Form C-103  
Revised July 18, 2013

WELL API NO. 30-015-23809
5. Indicate Type of Lease STATE <input type="checkbox"/> FEE <input checked="" type="checkbox"/>
6. State Oil & Gas Lease No.
7. Lease Name or Unit Agreement Name Pardue Farms 21 SWD
8. Well Number 1
9. OGRID Number 371643
10. Pool name or Wildcat

Pardue Farms 21 SWD #1 Workover NOI

Action 231850

Pardue Farms 21 SWD #1  
 990' FNL & 1,980' FEL, Unit B, Sec. 21, T24S-R28E, Eddy County, NM  
 API # 30-015-23809

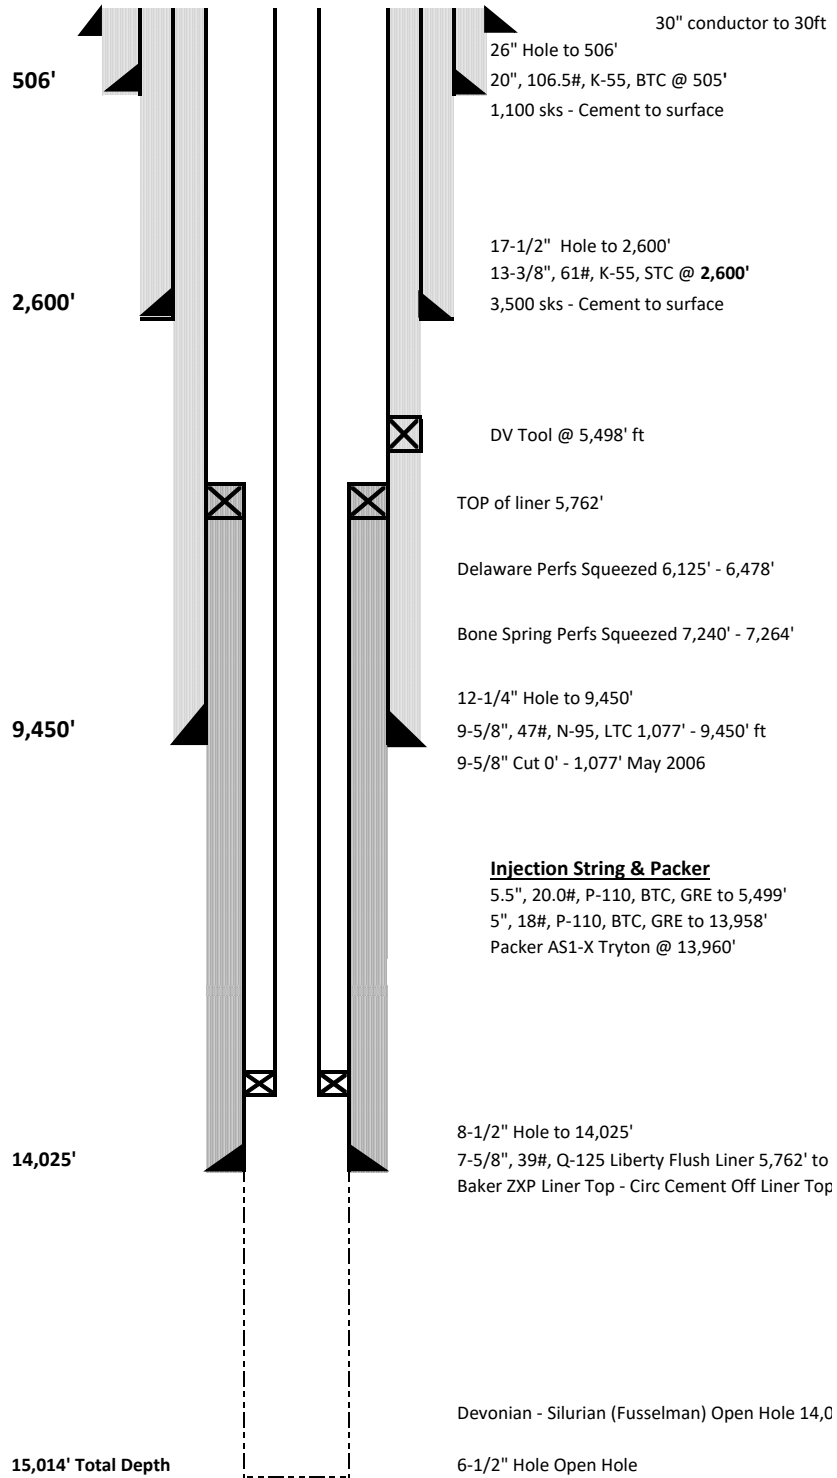
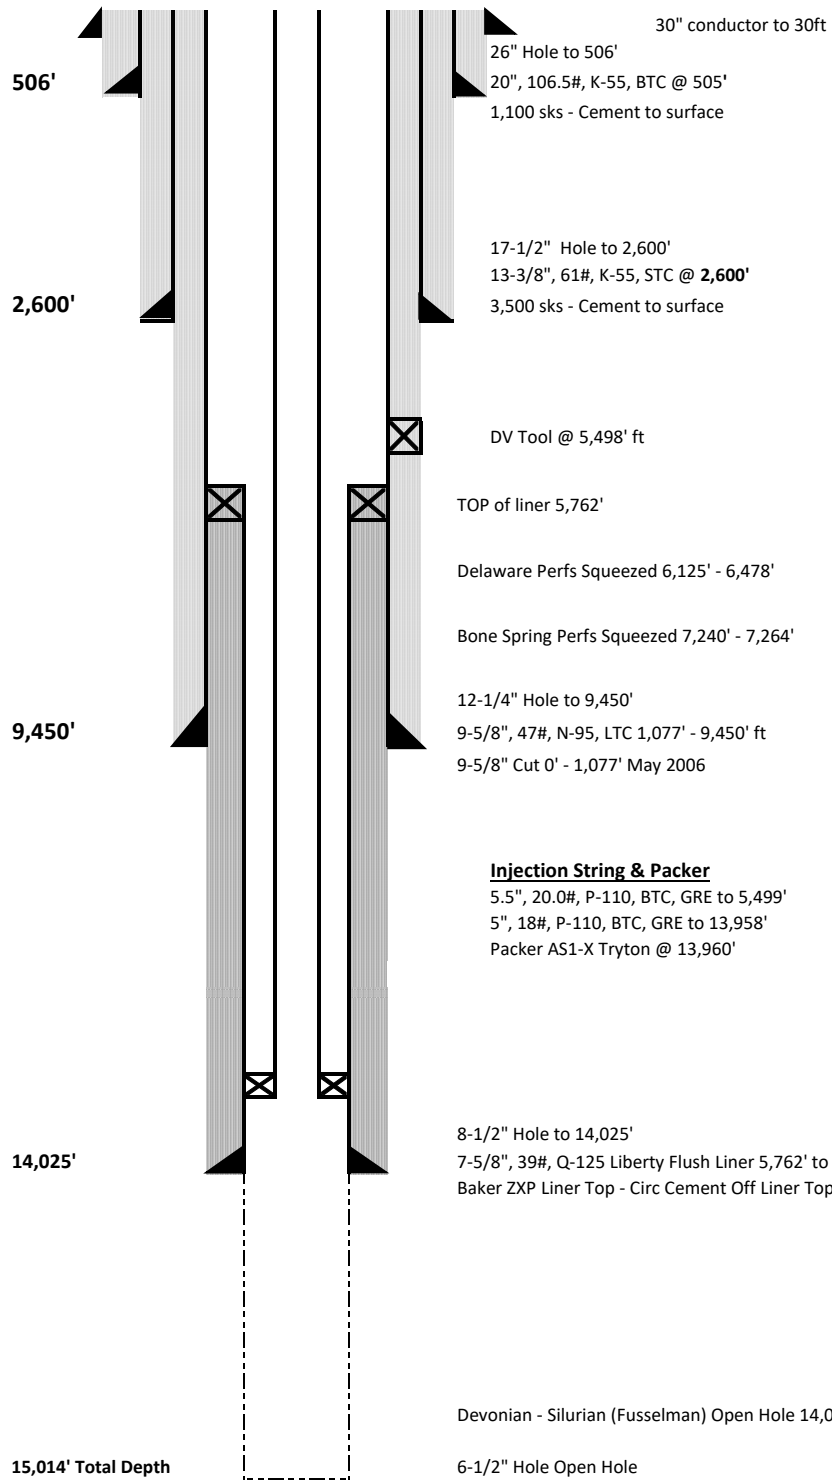
Created By	Condition	Condition Date
mgebremichael	please ensure that same size tubing as it is stipulated in the perspective order be re-installed and packer is set at not more than 100 ft. of the top of the open hole.	8/24/2023
